# Access Compliance Report

## Public Rights-of-Way

### (Curb Ramps)

Intersection ID: 30020	Main Street: SOLANO_DR	Cross Street: BERKELEY_PLACE_DR	Location: NW
ADA ID: 314AAACE818F8	Ramp Type: PerpDiag	Initial Pass/Fail: Fail	Overall Compliance: No
		Severity Score: 50

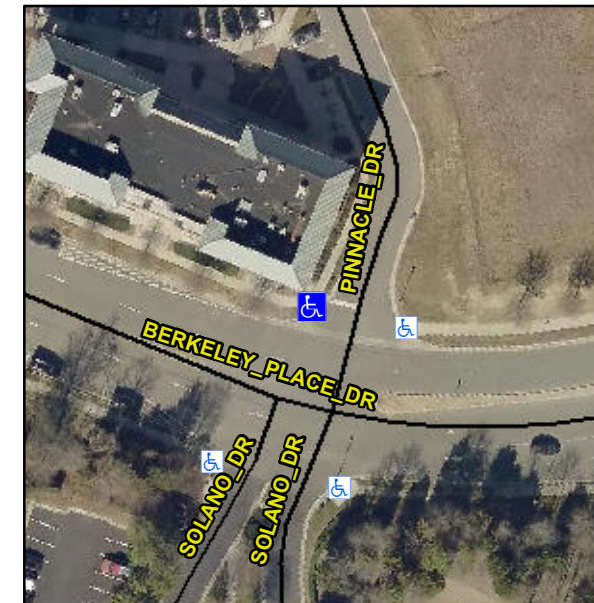
**R304.2.2, R304.5.3**

Compliance	Description	Data	Compliance	Description	Data
N/A	Ramp Length (in)	51.5	No	Ramp Slope (%)	12.4
Yes	Ramp Width (in)	70.5	No	Ramp XSlope (%)	7.6
N/A	Flare Type LT	N/A	N/A	Flare Type RT	N/A
N/A	Flare Slope LT (%)	N/A	N/A	Flare Slope RT (%)	N/A
N/A	Flare Traversable LT?	N/A	N/A	Flare Traversable RT?	N/A
N/A	Landing Length (in)	N/A	N/A	DWS Provided?	N/A
N/A	Landing Width (in)	N/A	N/A	DWS Contrast?	N/A
N/A	Landing Slope (%)	N/A	N/A	DWS Length (in)	N/A
N/A	Landing X Slope (%)	N/A	N/A	DWS Full Width?	N/A
N/A	Landing Curb? (Y/N)	N/A	N/A	DWS Offset (in)	N/A
N/A	Shared Landing?	N/A			
N/A	Gutter Ponding?	N/A	N/A	Gutter Slope (%)	N/A
N/A	Gutter Lip Ht (in)	N/A	N/A	Gutter X Slope (%)	N/A
N/A	Painted X Walk1?	No	N/A	Painted X Walk2?	No
	X Walk 1 Direction	To S		X Walk 2 Direction	To E
N/A	X Walk 1 Width (in)	N/A	N/A	X Walk 2 Width (in)	N/A
	X Walk 1 Slope (%)	0.3		X Walk 2 Slope (%)	2.8
	X Walk 1 X Slope (%)	3.2		X Walk 2 X Slope (%)	0.3

**Remove & Replace Curb Ramp With Two New Directional Ramps or Equivalent.**
